Memorandum

Reference: Angeline Street North Reconstruction MCEA
Discussion related to the Active Transportation Master Plan
Ainley File No. 18545-2

Staff Memo

Re: Comments on Angeline Street North Reconstruction MECA Memo dated May 15, 2025

ALTERNATIVE 2B

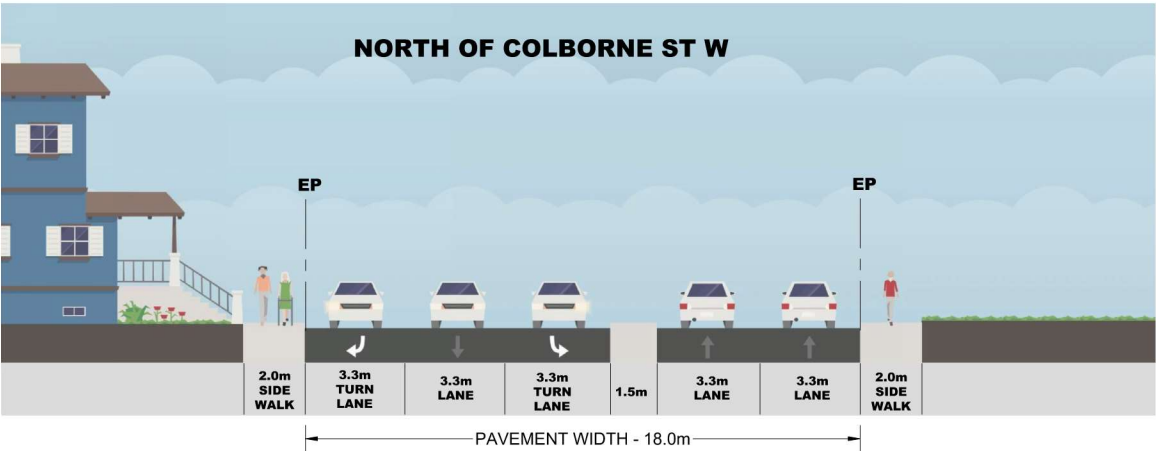
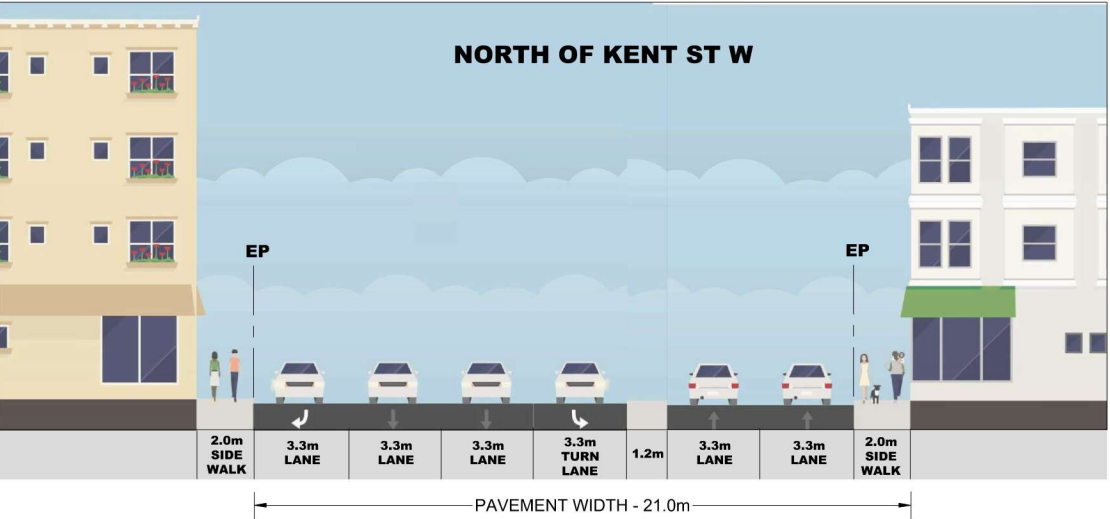
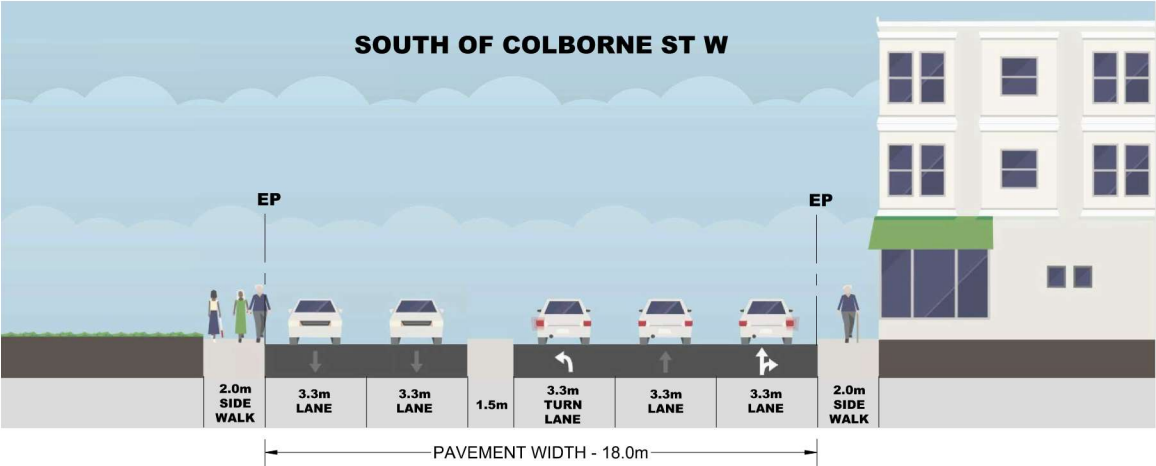
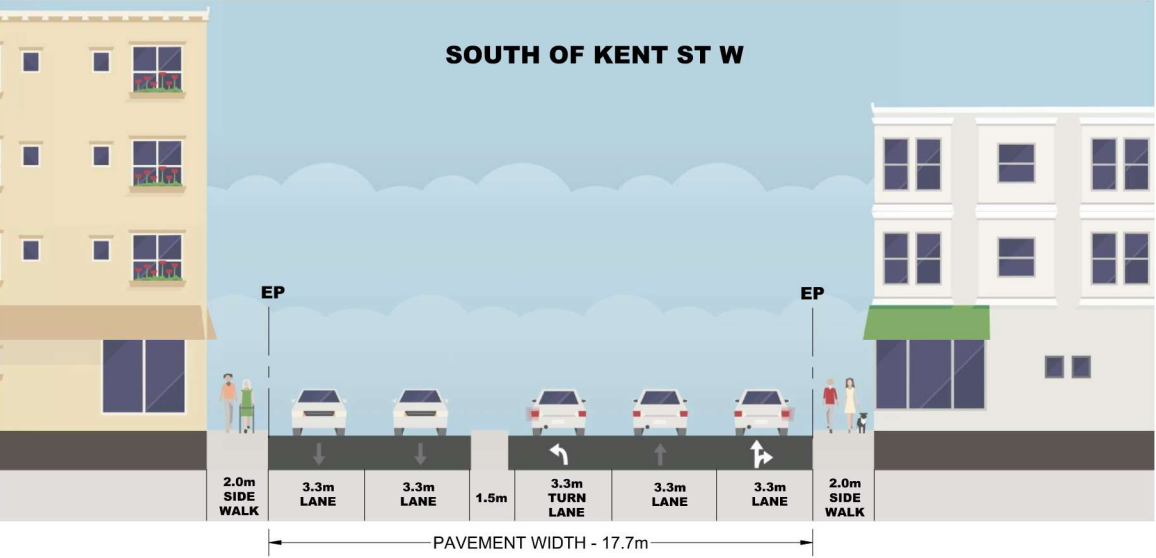
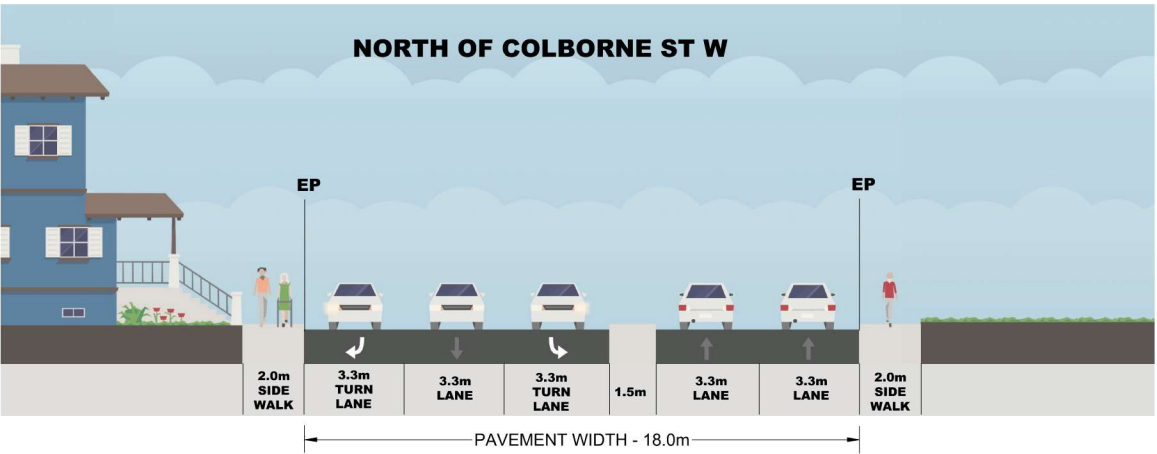
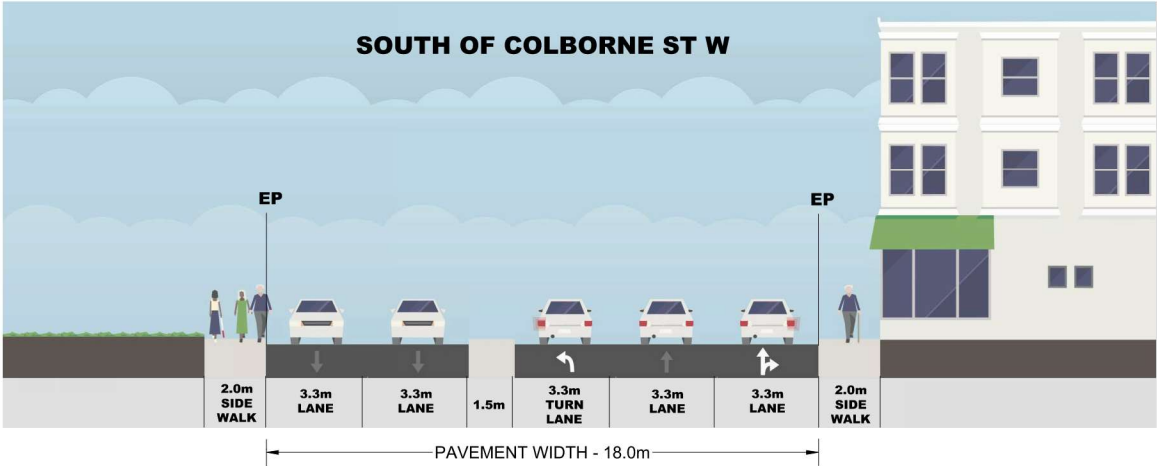
3. There is policy support for all active transportation facilities and features bulleted under "Summary of Evaluation" on page 6 of the Memo.
4. We would prefer to see the MUP extend to Kent Street, but understand there are limitations on the feasibility. We accept the Memo's suggestions for where the MUP would terminate. While it may terminate 'abruptly,' we see this as progress towards implementing the broader network.
5. Implementing the MUP on the east side of Angeline appears preferable to the west side to reduce potential conflicts with driveways.
6. We would appreciate an opportunity to comment at the detailed design stage. Ideally, drawings could be brought to a future Active Transportation Implementation Group meeting.
